PBK, P.O. BOX 880, GRIFFIN, GA 30223

ADDENDUM NUMBER THREE: DATED: October 08, 2026

This addendum forms a part of the Contract Documents and modifies the original Specifications and Drawings dated September 11, 2026, as noted below. **Acknowledge receipt of this Addendum in the space provided on the Bid Form;** failure to do so may subject bidder to disqualification.

Whitewater High School
Renovations

1 LEVEL 1 - AREA K FLOOR PLAN 1/8" = 1'-0"

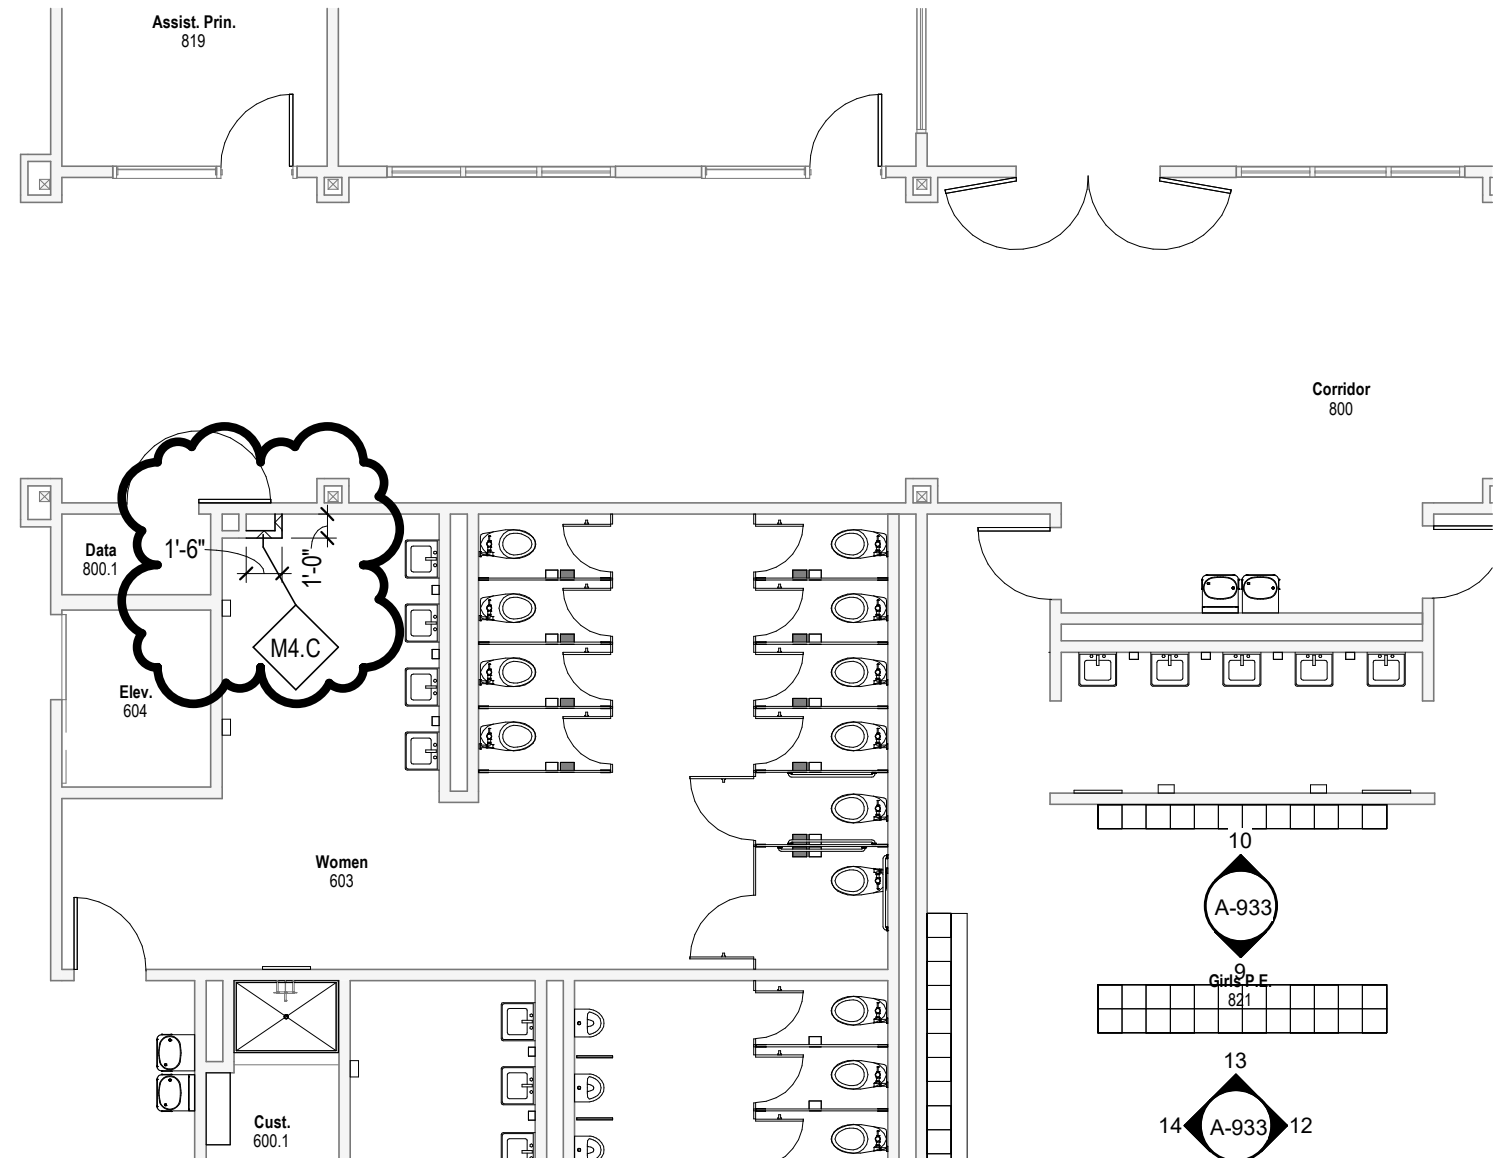
5. SHEET A-101K FLOOR PLAN SECTOR K

A. Detail No.1, Level 1 – Area K Floor Plan

1. A CMU chase in Women 605 to accommodate mechanical revisions is included in this addendum. Refer to Supplementary Drawing SDA-101K included in this addendum.

MECHANICAL DEMOLITION
LOWER LEVEL - AREA K
FLOOR PLAN

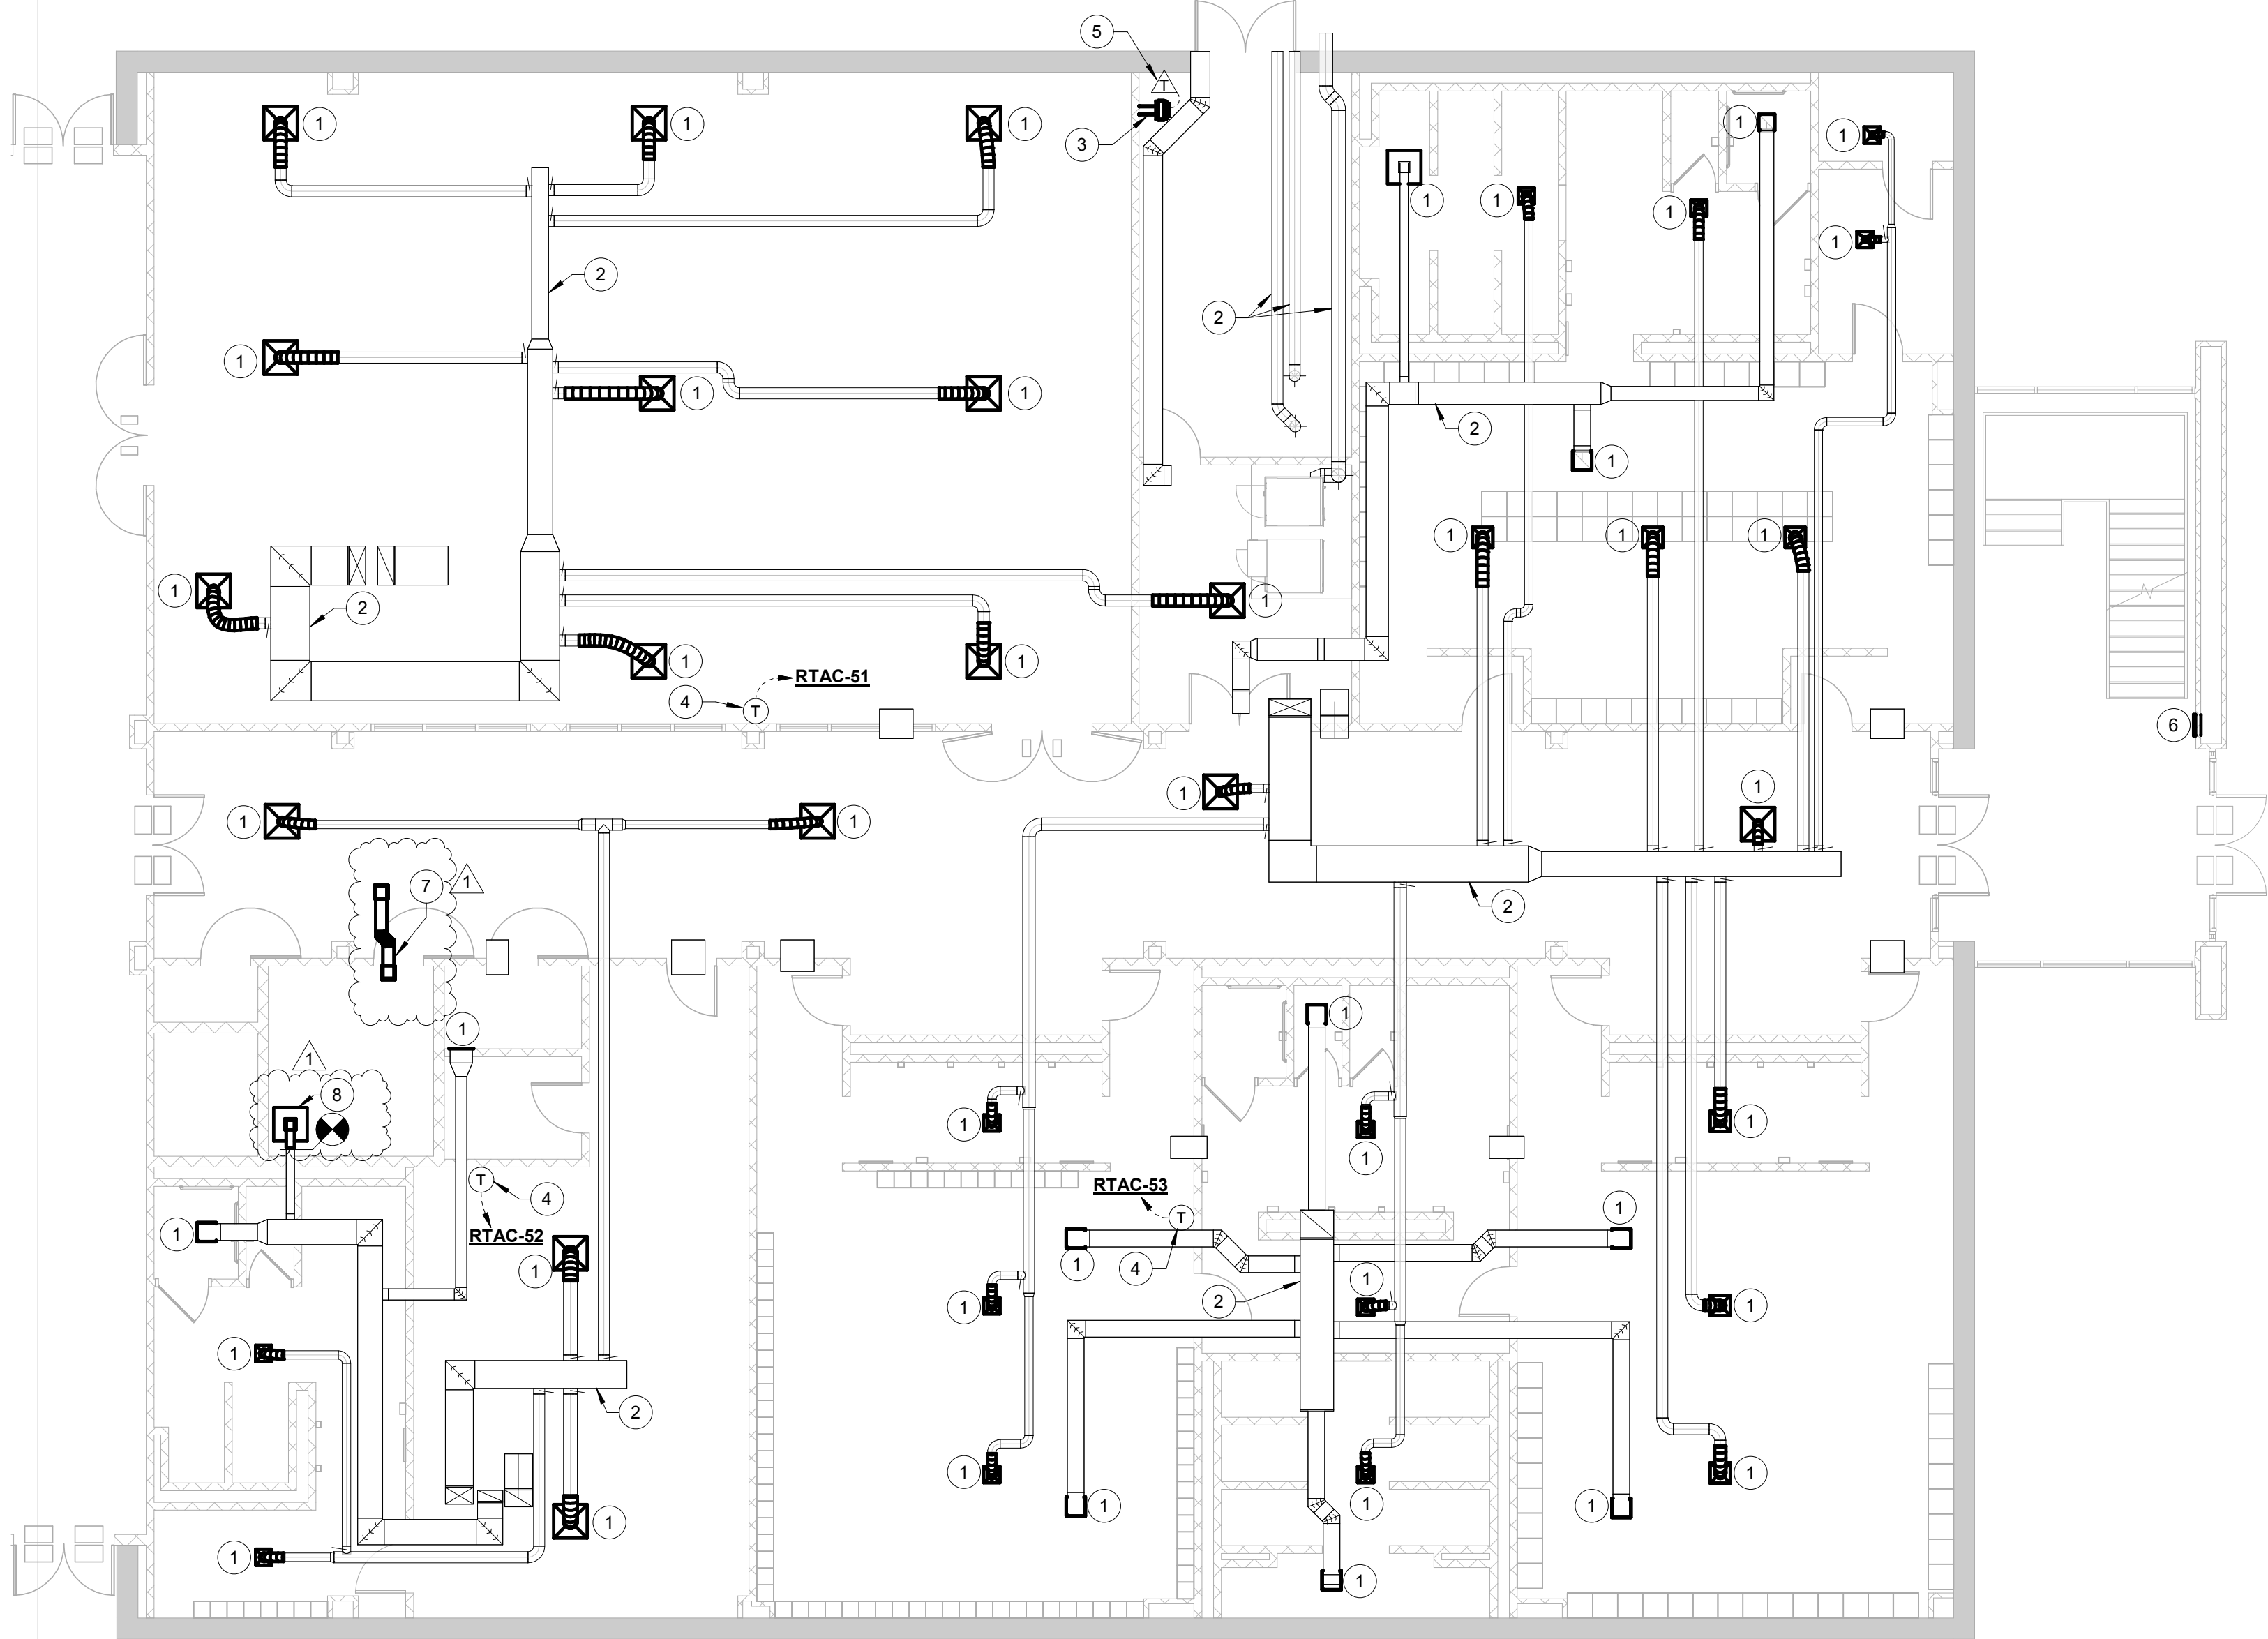
1. SHEET MD-101K.LL – MECHANICAL DEMOLITION LOWER LEVEL - AREA K FLOOR PLAN
 - A. Delete Sheet MD-101K.LL in its entirety and replace with Sheet MD-101K.LL included in this addendum.

MD-301

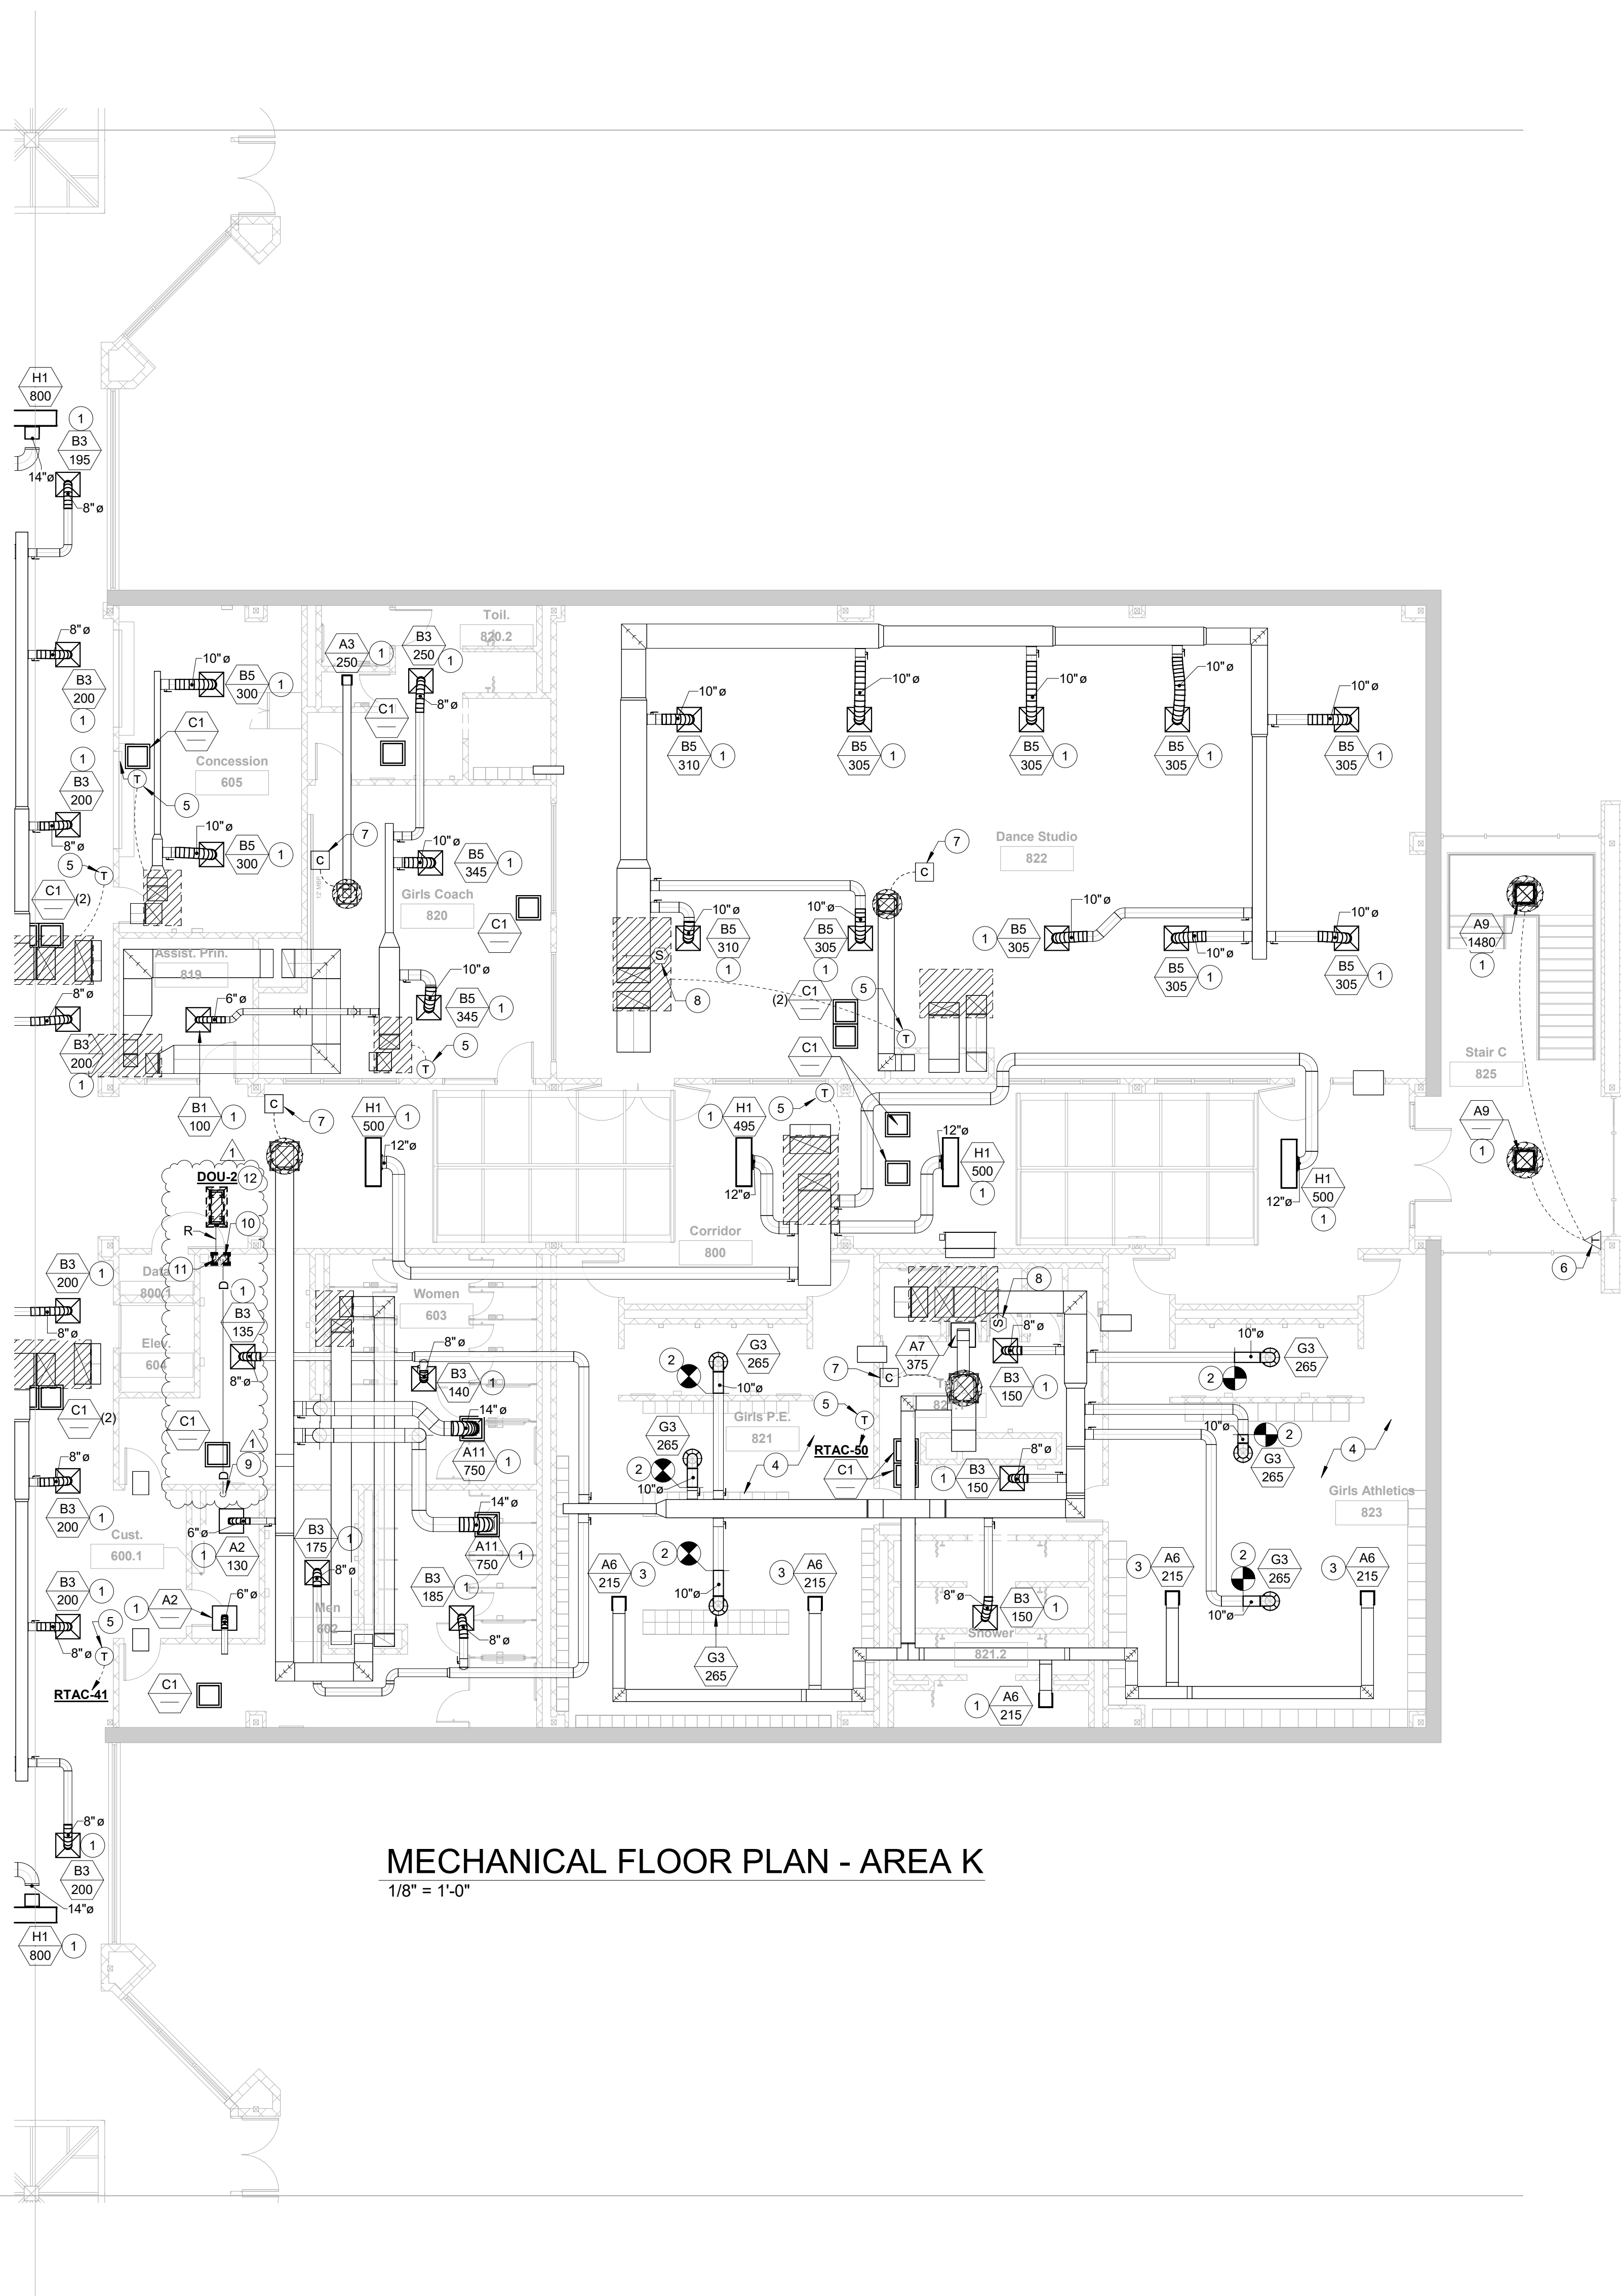
2. SHEET MD-301 - MECHANICAL ROOM LARGE SCALE DEMOLITION FLOOR PLAN
 - A. Delete Sheet MD-301 in its entirety and replace with Sheet MD301 included in this addendum.
